ADDENDUM NO. 1

This addendum includes Item Number 1-1 thru 1-76. This addendum item shall be fully incorporated into the Bidding/Contract Documents and have the same force and effect as though originally included.

Life Sciences Collaboration
1910 N. Antelope Valley Parkway
Lincoln, Nebraska
TCEP No.: 716-002-12
Davis Design.: 12-0077
BVH No.: L12018.unl
November 27, 2013

Item 1-44: Sheet A2.11 - Skywalk Exterior Building Elevations – Area A

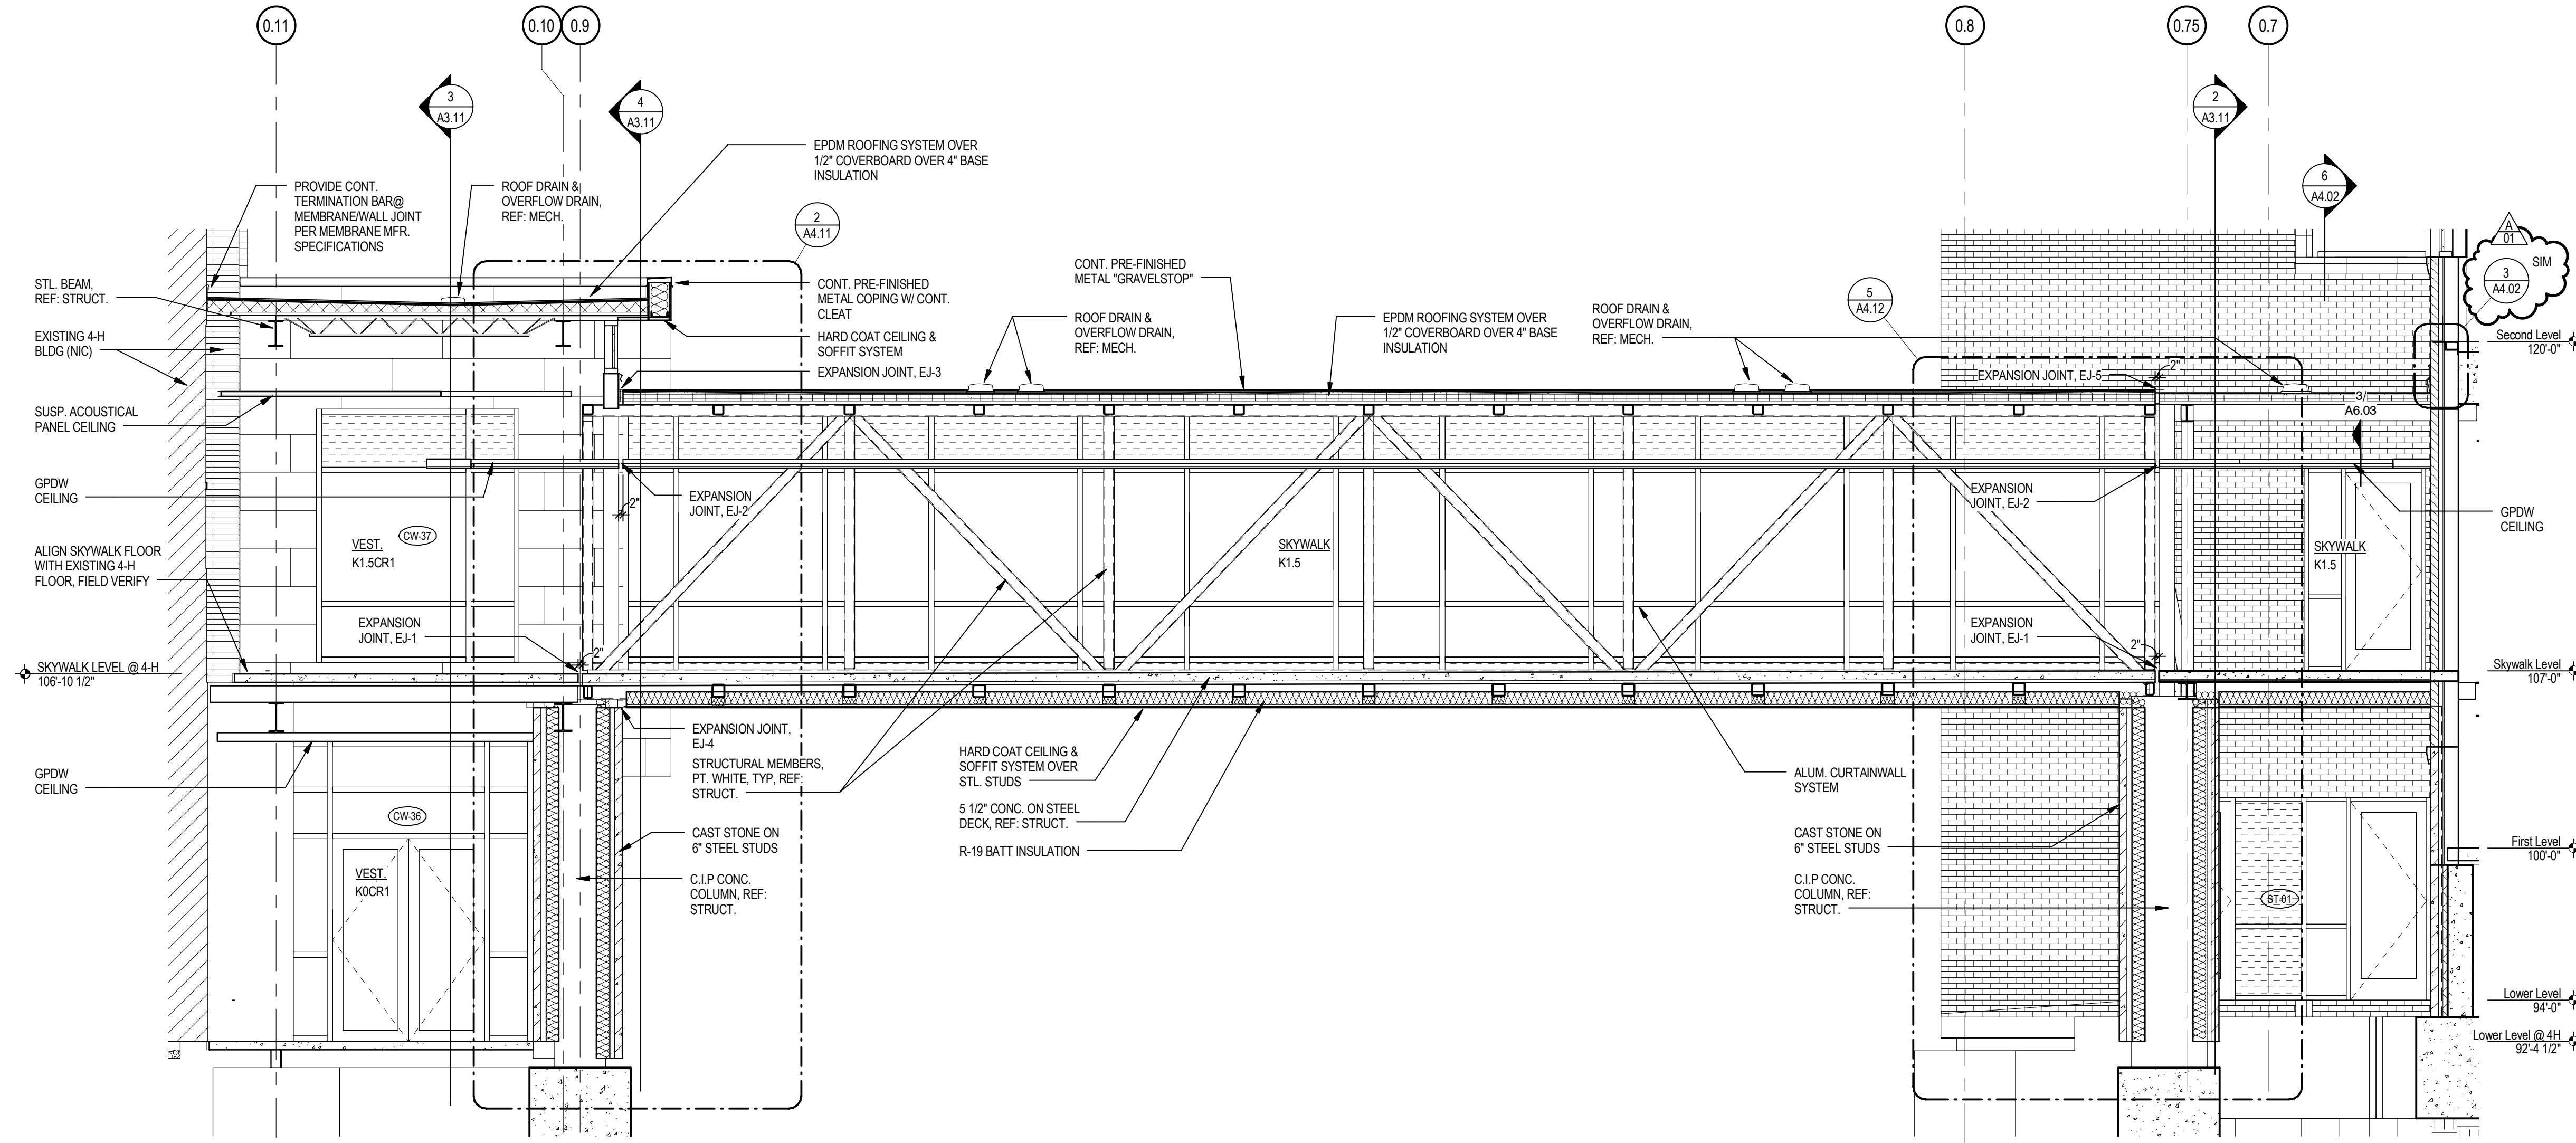
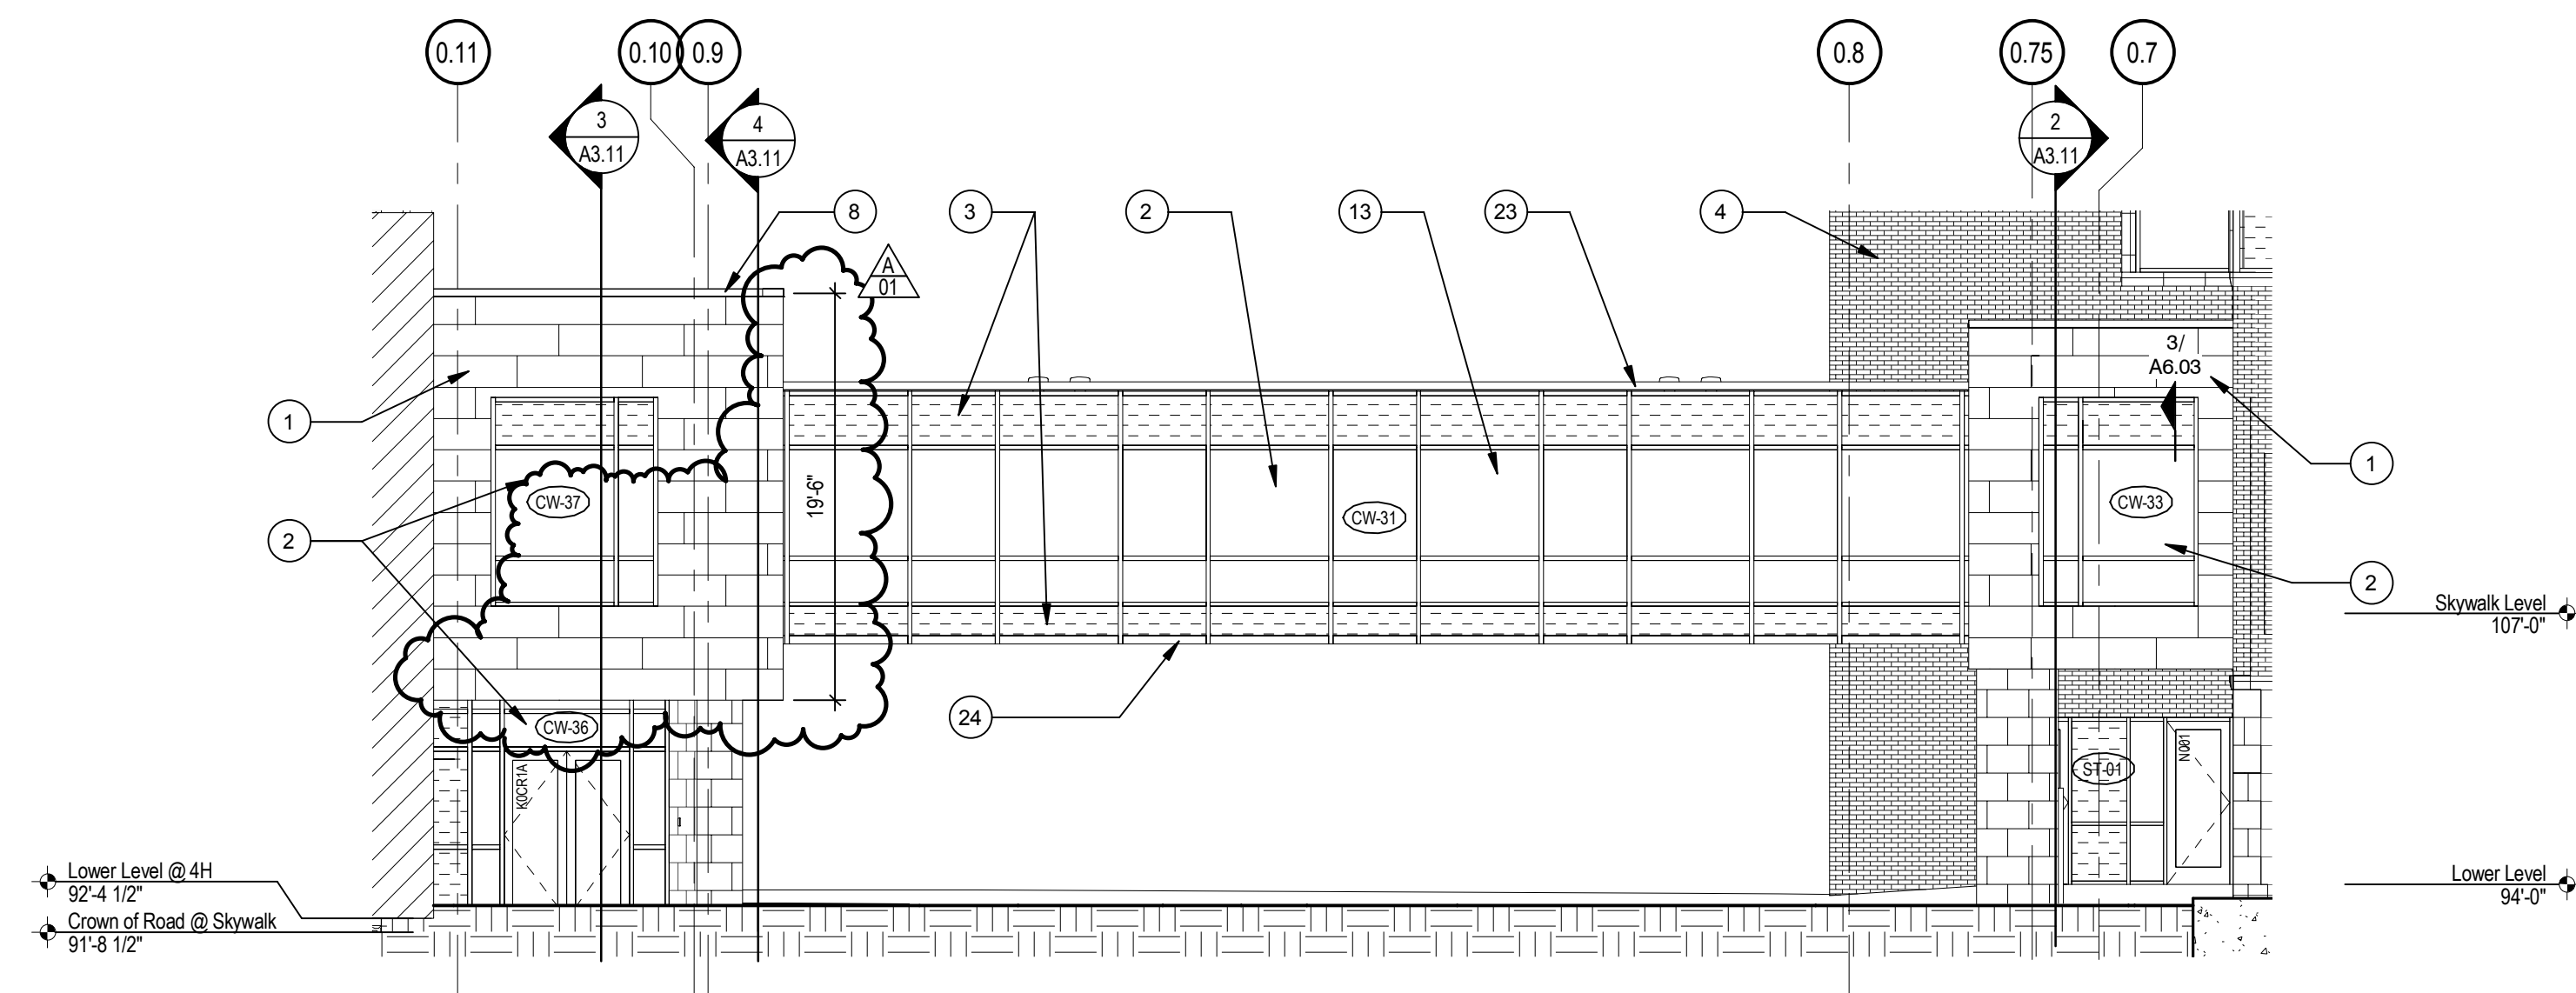
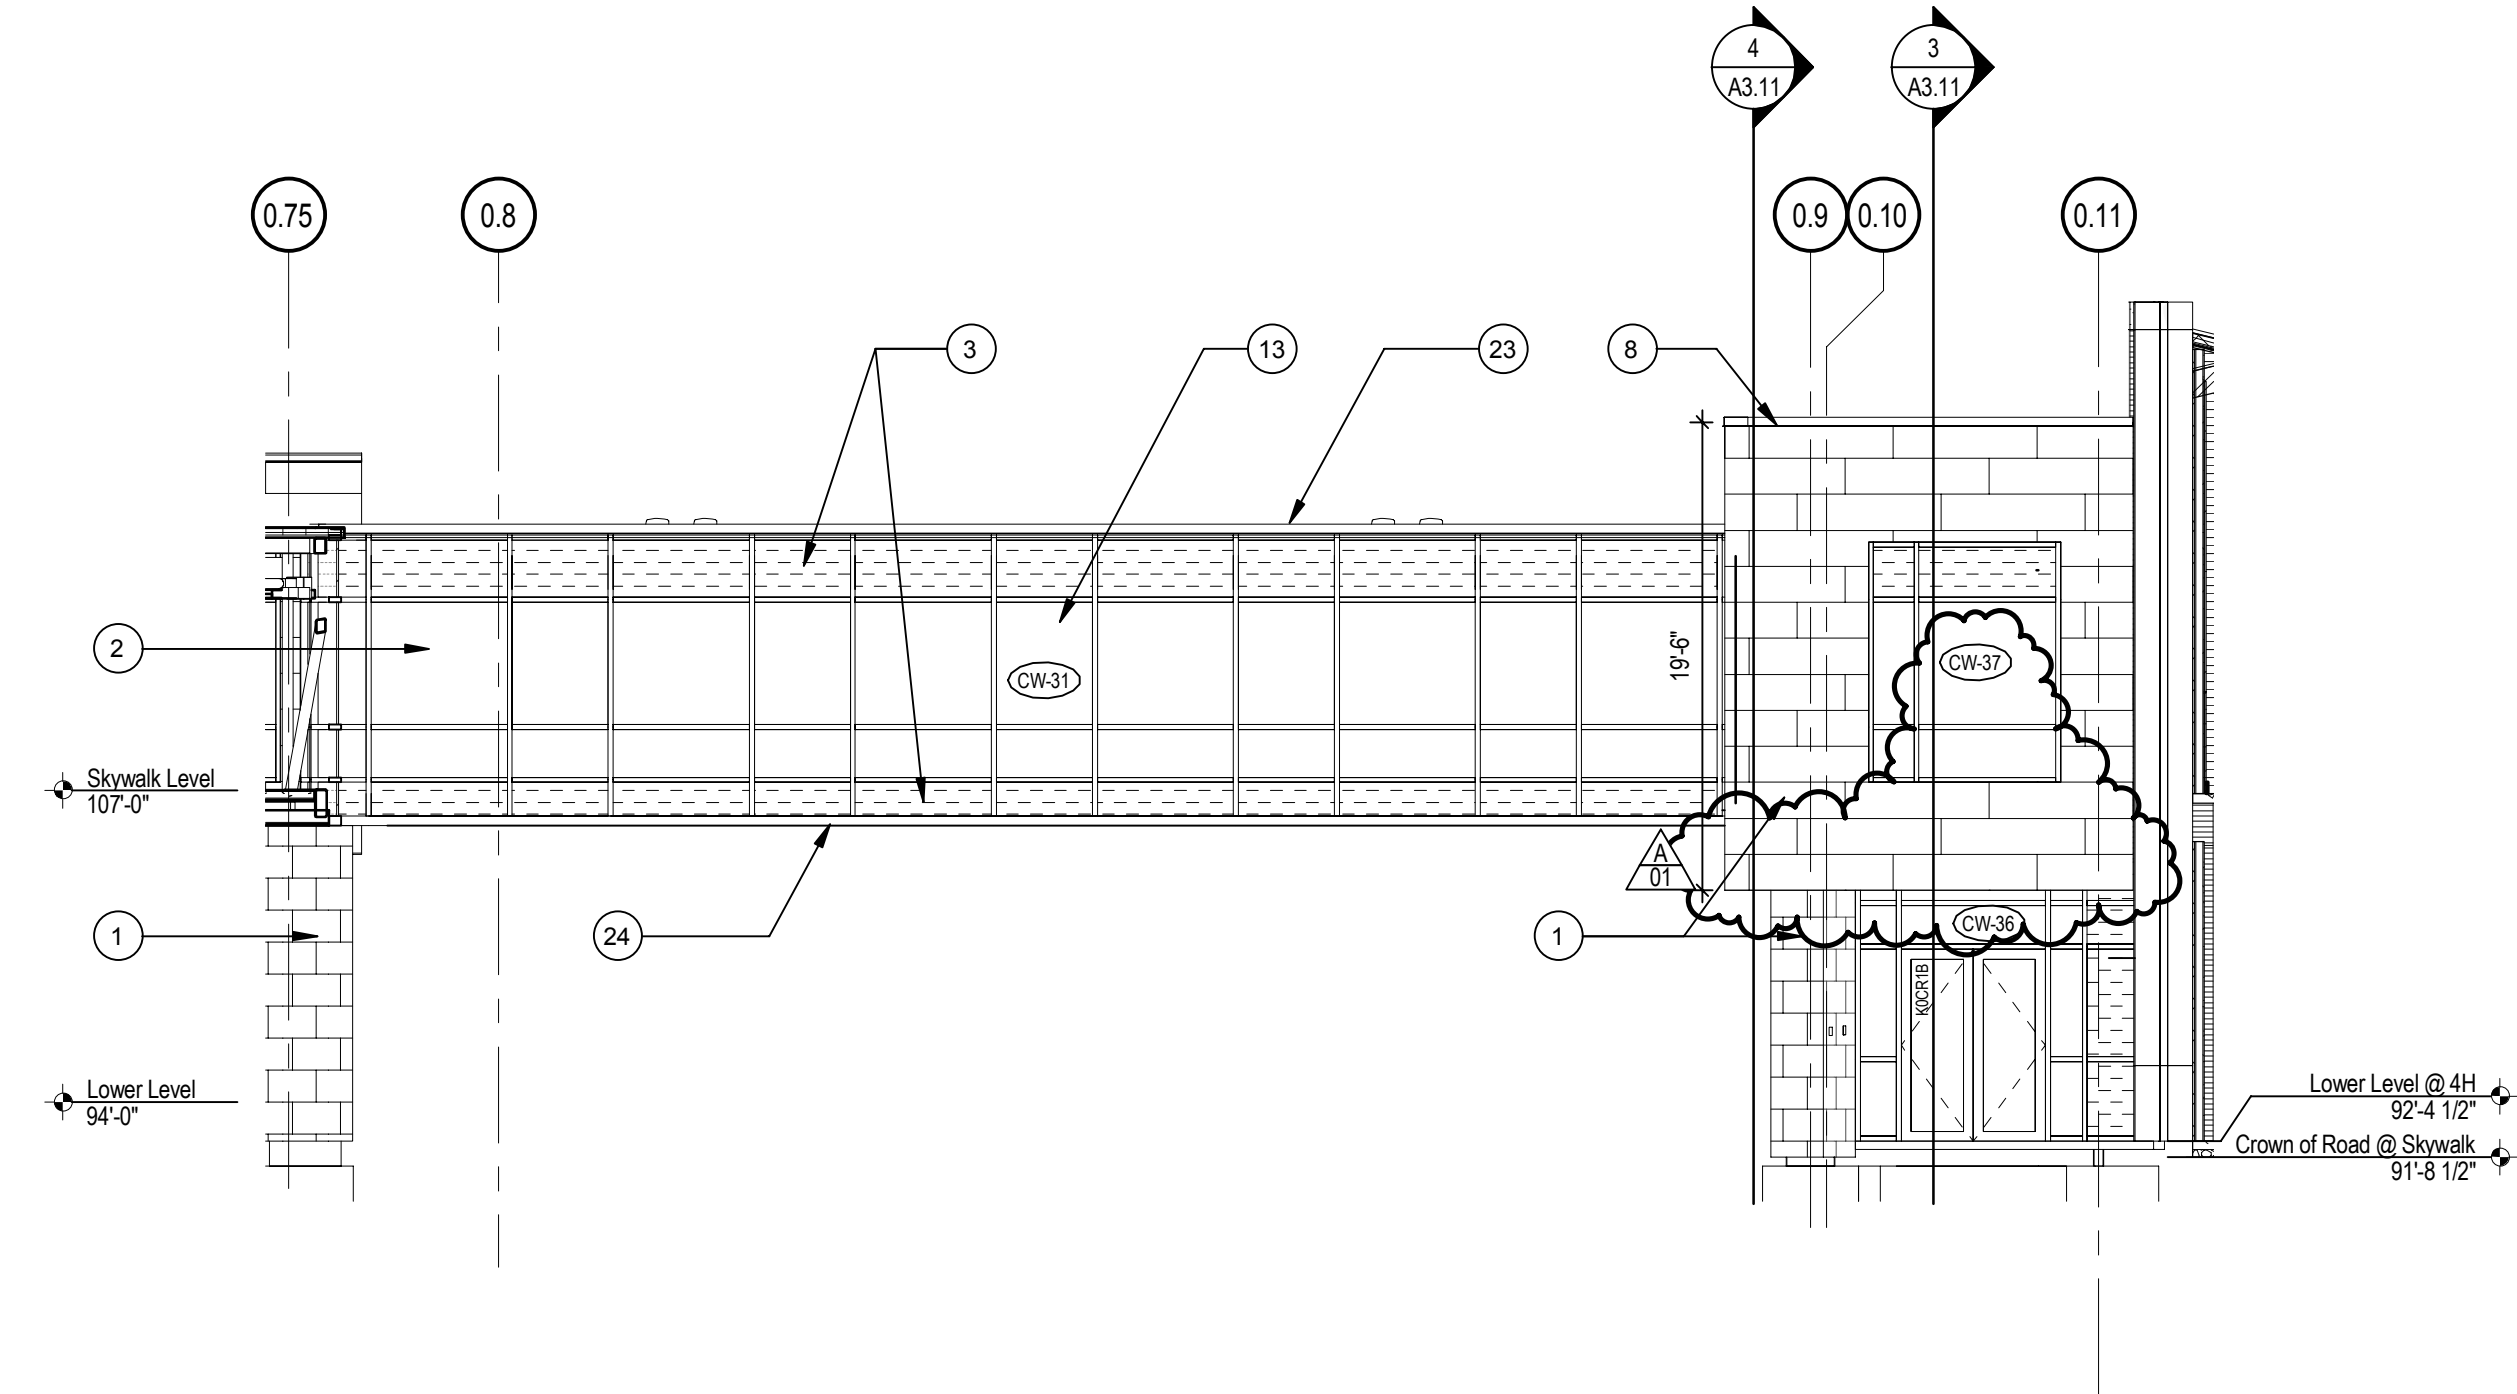
See revised sheet for updated Curtainwall frame type reference tags and revised height of wall at Vestibule K1.5CR1.
